SUBJECT: NuScale Power, LLC Supplemental Response to NRC Request for Additional Information No. 04 (eRAI No. 8760) on the NuScale Design Certification Application

Response to Request for Additional Information Docket No. 52-048

eRAI No.: 8760

Figure 3—202 KENO-V.a model of the spent fuel pool

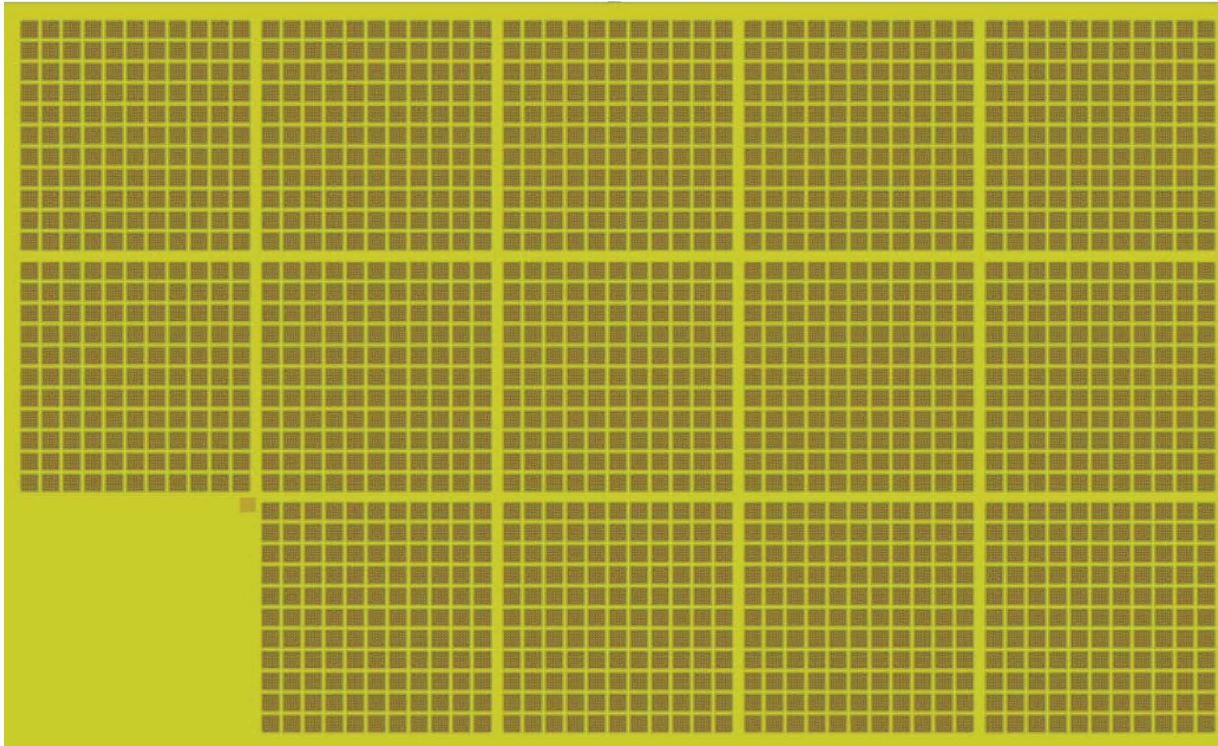
For the abnormal condition of an assembly dropped outside of the fuel storage rack, the staff observed that the current assumed location of the dropped fuel assembly, shown in Figure 3-202 of TR-0816-49833-P, does not appear to be the most limiting in terms of neutronic coupling. The staff expects that a fuel assembly dropped equidistant to and as close as possible to the three racks closest to the bottom left-hand corner of the figure would be most limiting.

Therefore, to demonstrate compliance with GDC 62 and 10 CFR 50.68, please either (a) provide justification as to why the current assumed location is conservative or (b) provide a new analysis of the more limiting location. In addition, update TR-0816-49833-P with this information accordingly.
